## MEMORANDUM

**DATE:** MAY 7, 2014

**RE:** STAFF UPDATE FOR CUP#2260

# Operations Plan Crazy Acres (Revised 5/7/14)

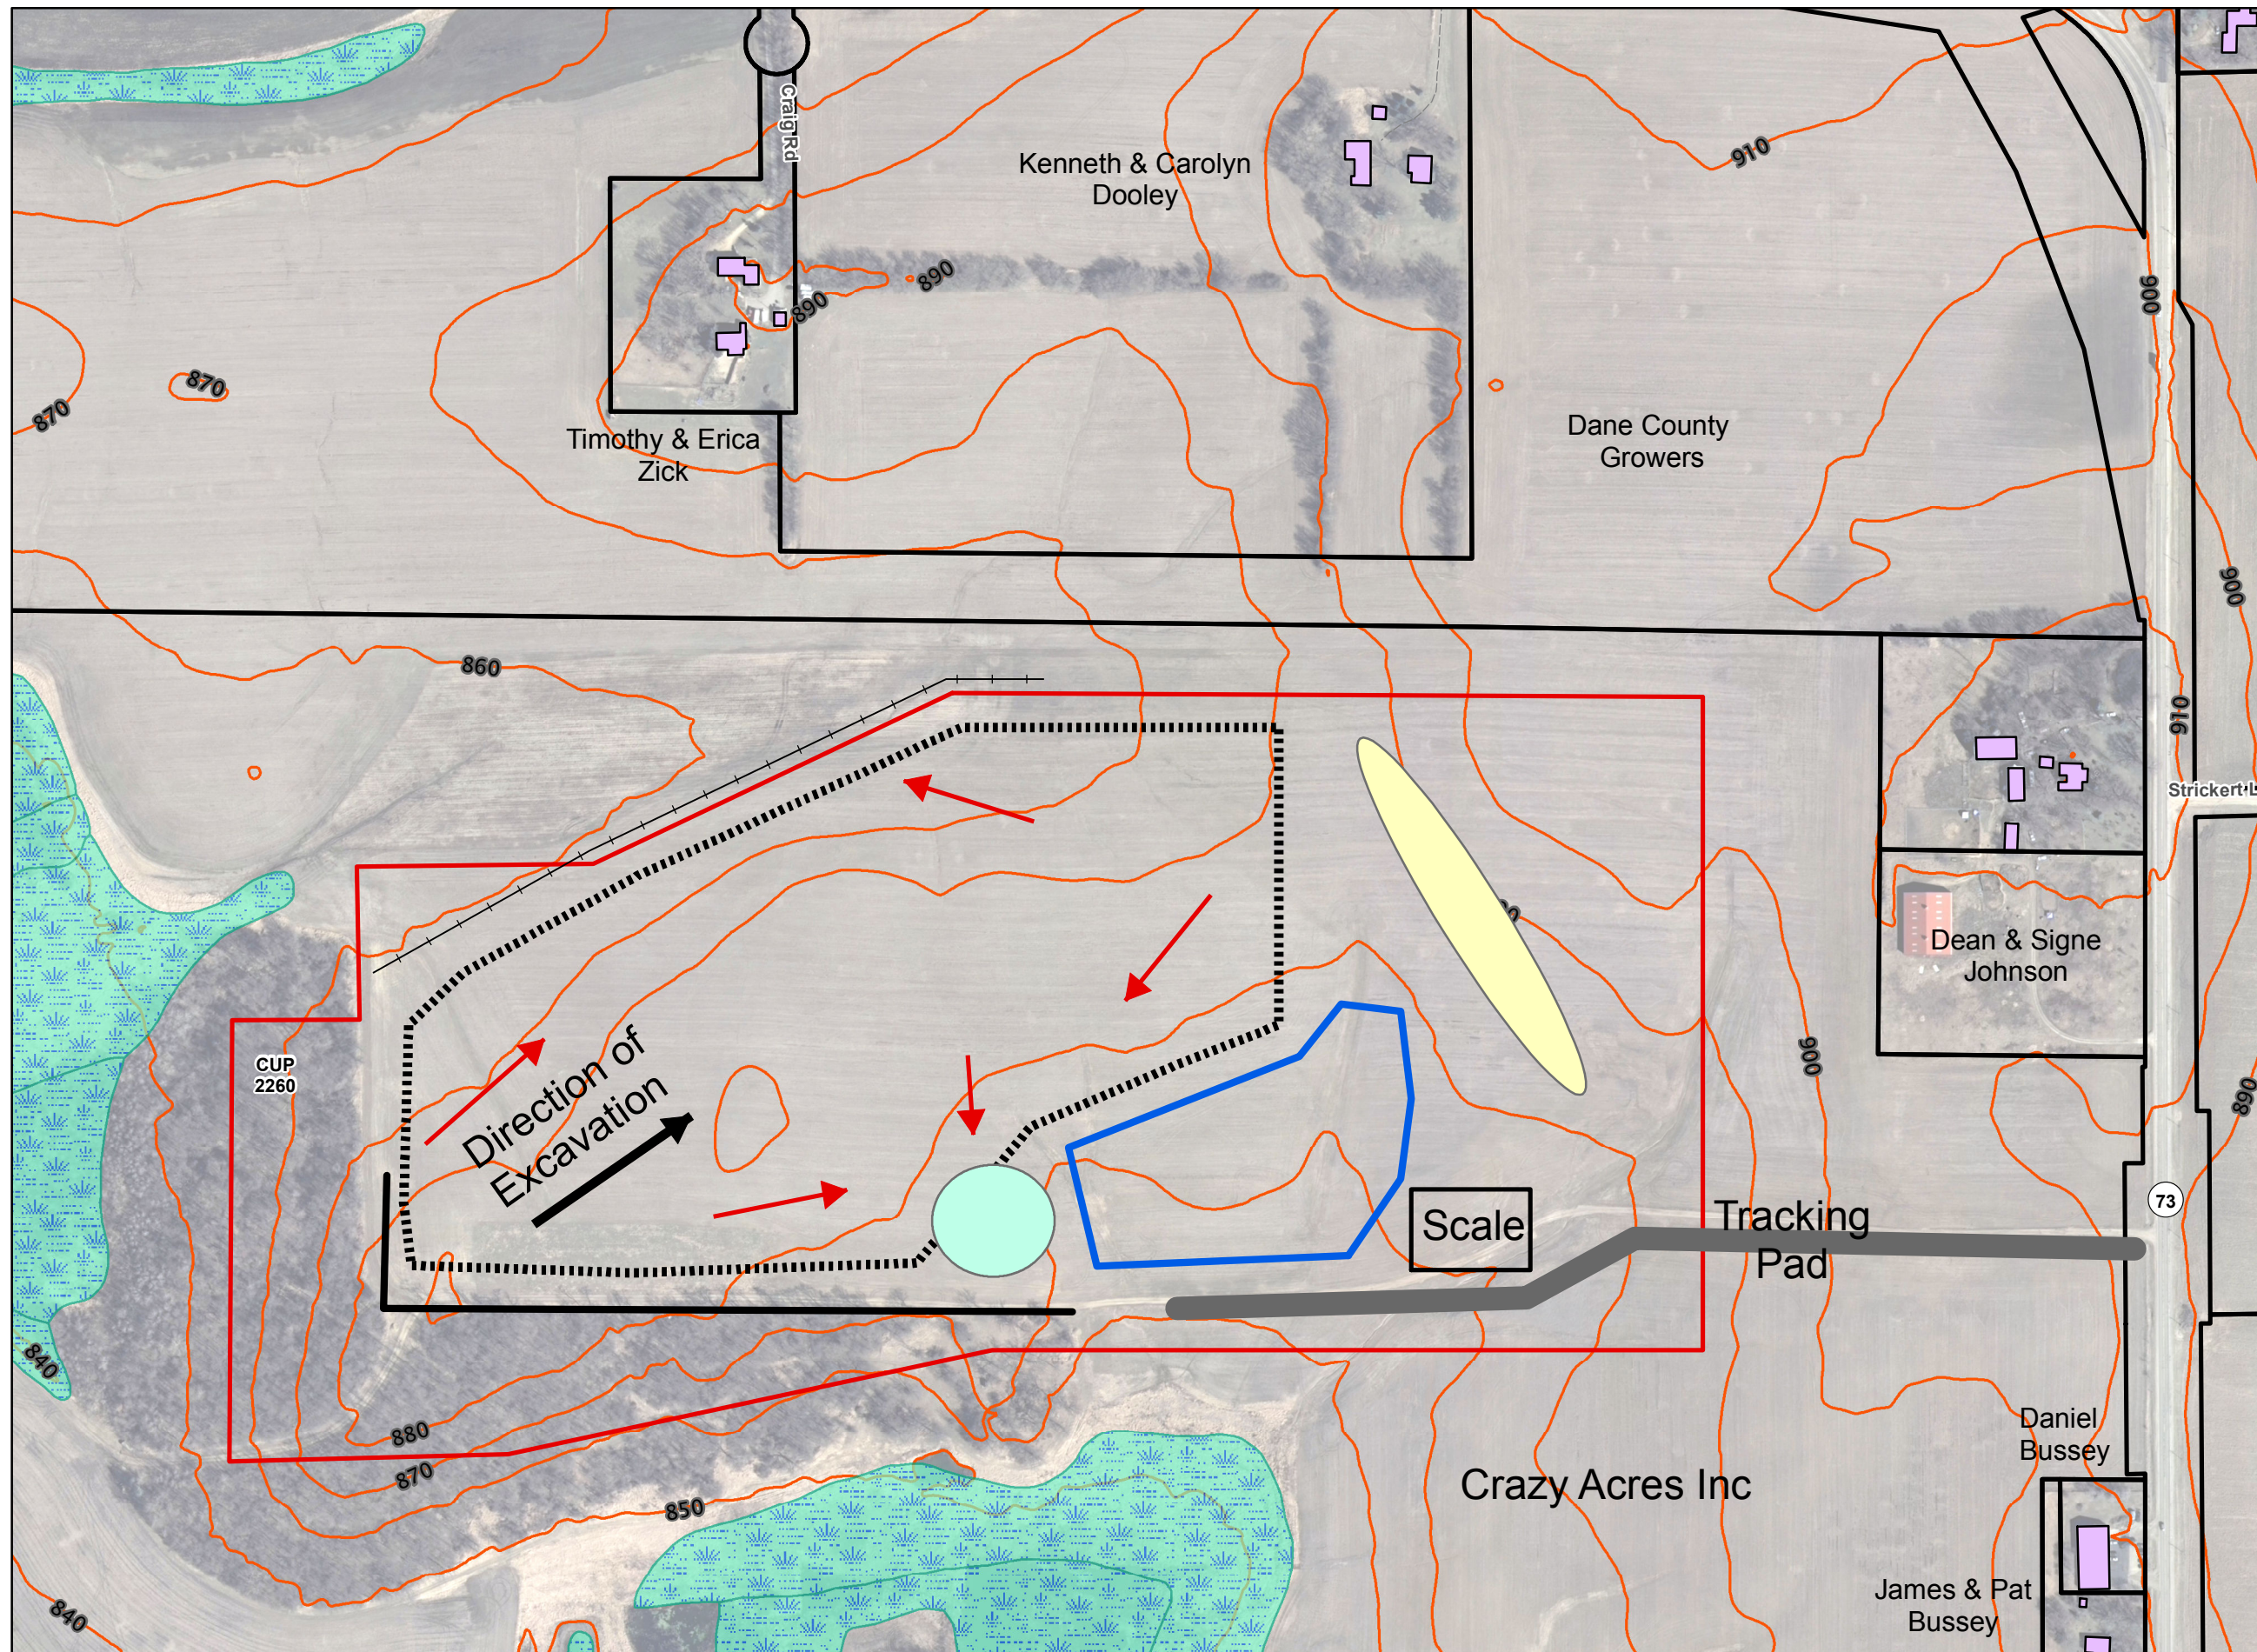
4. The applicant shall apply for and receive all other required local, state and federal permits.
5. The operator shall develop and operate the site according to the site/operations and phasing plan dated 5-07-2014. This plan shows an active area of 29 acres within the CUP boundary.

8. Reclamation shall meet requirements of Chapter 74 of the Dane County Code of Ordinances.
9. The driveway accessing the subject site shall be paved for a distance of at least 100 feet from the public road. The operator shall maintain the driveway in a dust free manner in accordance with local, state, and federal regulations, and shall clean any dust or mud tracked onto public roads. A 20' x 50' tracking pad shall be installed as designated on the Operations Plan map, dated 05/07/14..

10. The operator and all haulers shall access the CUP site from US Highway 73 as depicted on the operations plan dated 05-07-14.
11. The access to the driveway shall have gates securely locked when the extraction site is not in operation. The site shall be signed "no trespassing."
